RESUBMISSION

CLIENT: BYFORD CENTRAL PTY LTD
PROJECT: BYFORD CENTRAL STAGE 5 A,B
TITLE: SEWER RETICULATION PLAN

DESIGNED: B.PATON DRAWN: L. VAN DER MEER WAPC No: 129226 130563 SCALE: 1:1000
CHECKED: *[Signature]* 21/6/07 DRAWING No. 2455 / 102 / 3
APPROVED: *[Signature]* 21/6/07

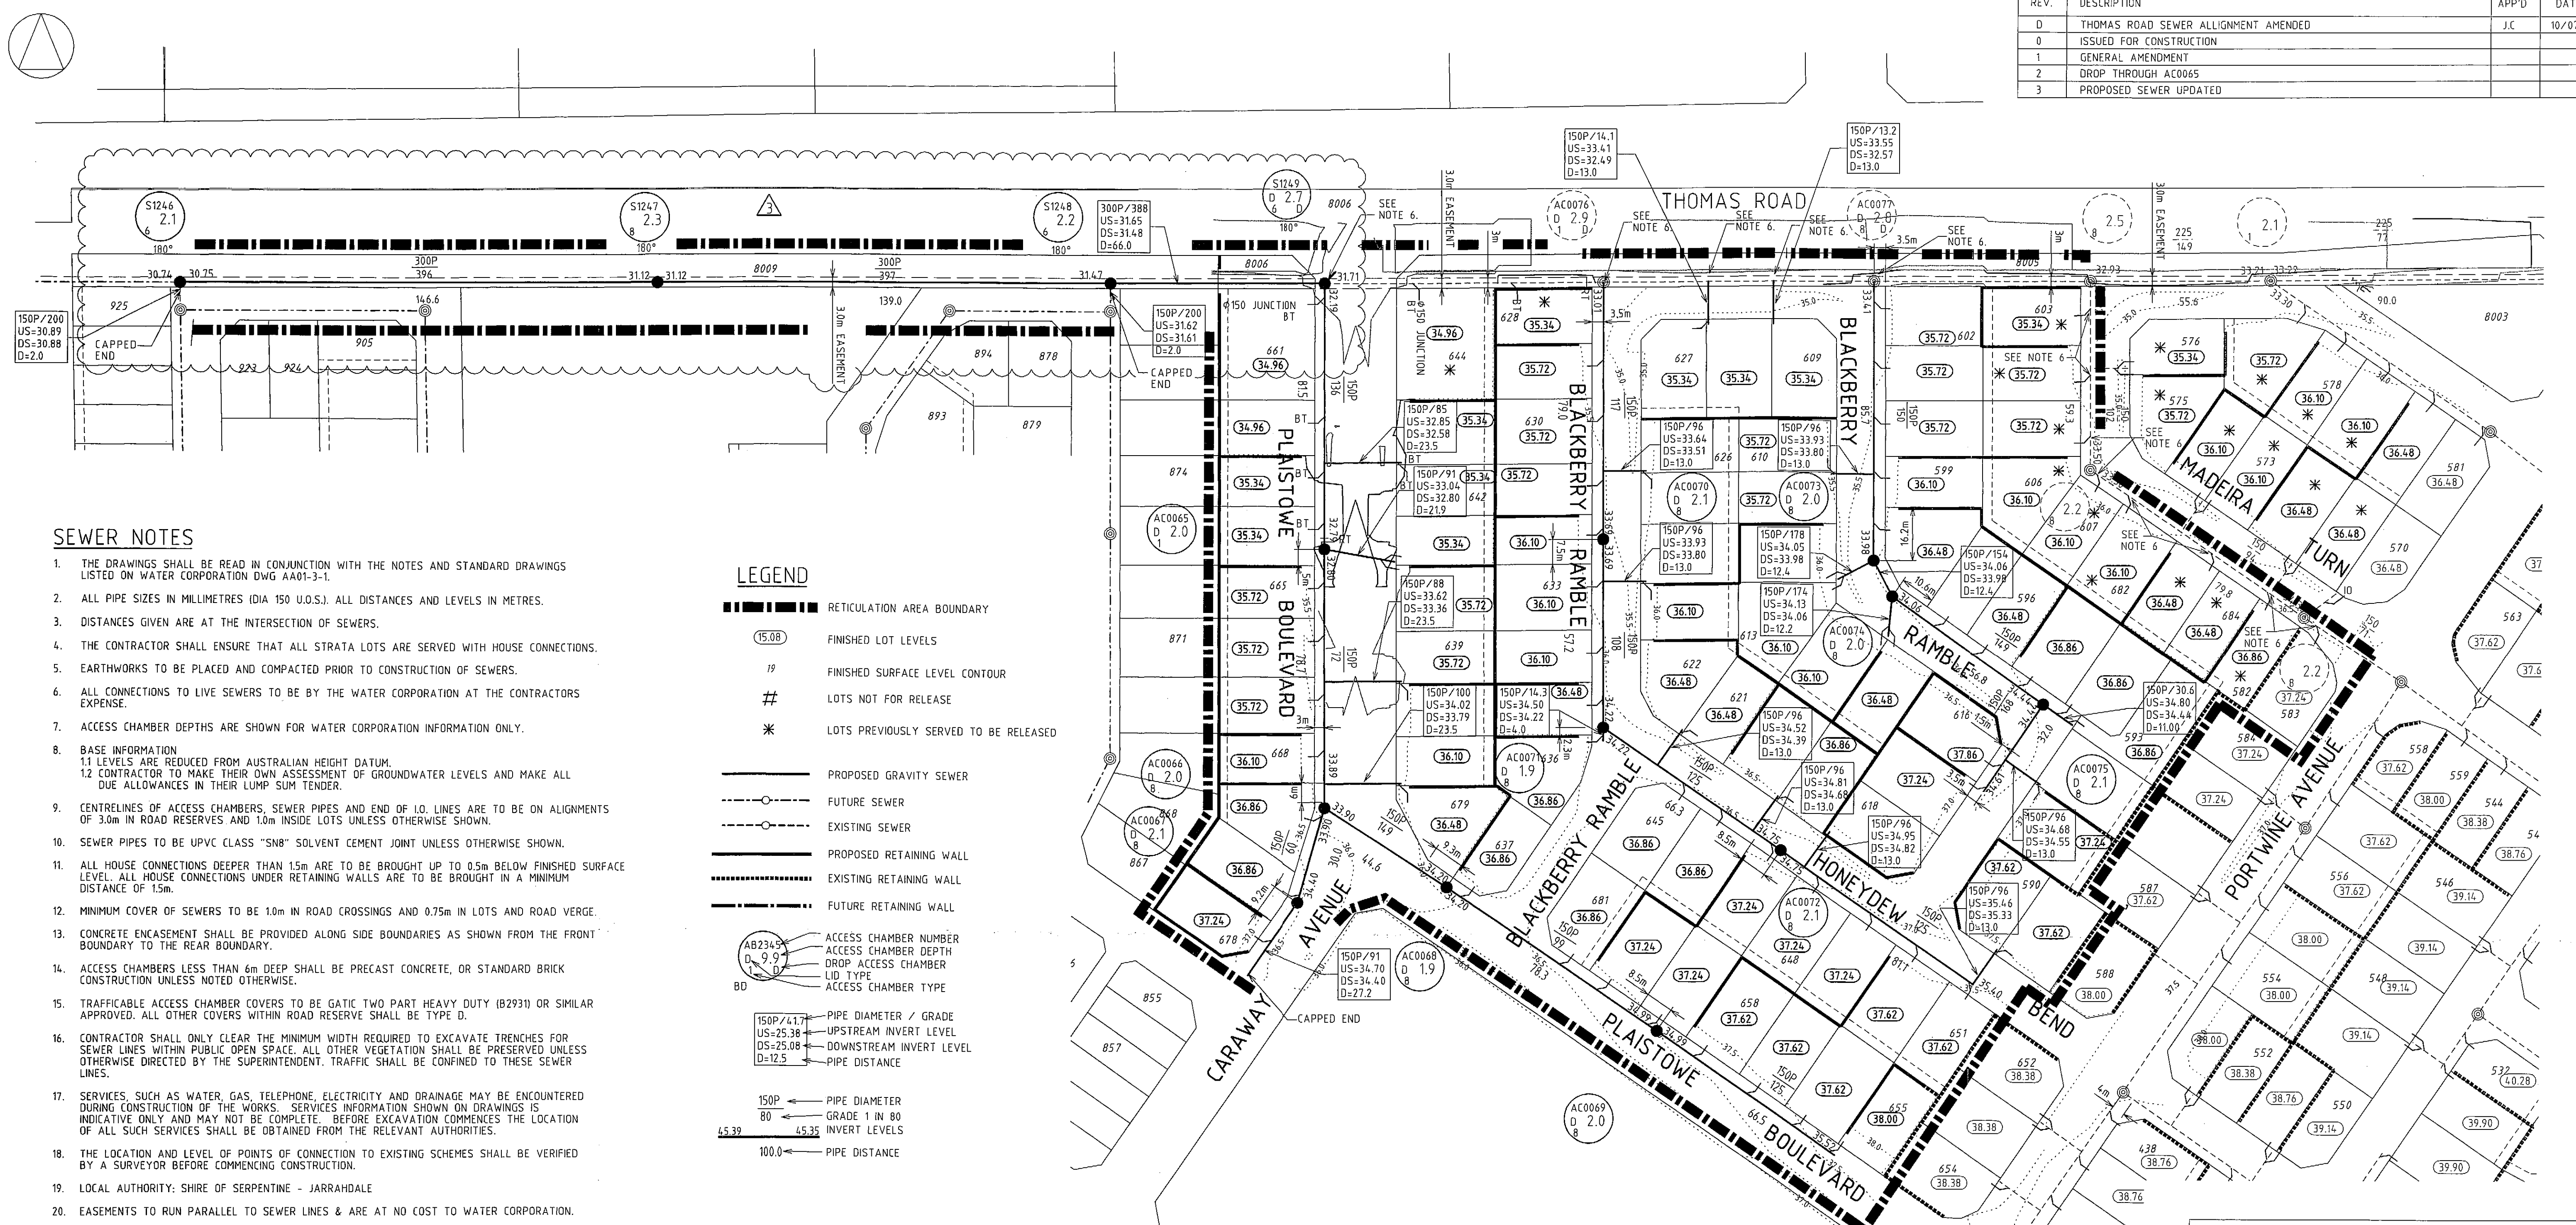
This plan is accepted as complying with overall sewerage planning. Compliance with Water Corporation Sewerage Manual has not been checked and remains the responsibility of the Consulting Engineer.

- APPROVAL SUBJECT TO
- FINALISATION AND CONSTRUCTION OF THE DN 375/300 MAIN SEWER CONNECTING LINK TO THE EXISTING BYFORD WASTEWATER PUMPING STATION No 1 TO THE CORPORATION'S SATISFACTION (REFERENCE PLAN IN04).
 - CONNECTION OF THE RETICULATION WORKS TO THE CORPORATION'S WASTEWATER SCHEME TO THE WATER CORPORATION'S SATISFACTION.
 - COMPLETION OF THE REQUIREMENTS OF THE LAND DEVELOPMENT AGREEMENT TO THE CORPORATION'S SATISFACTION.
 - NO LOTS ARE TO BE RELEASED UNTIL OUTSTANDING MATTERS ARE RESOLVED.
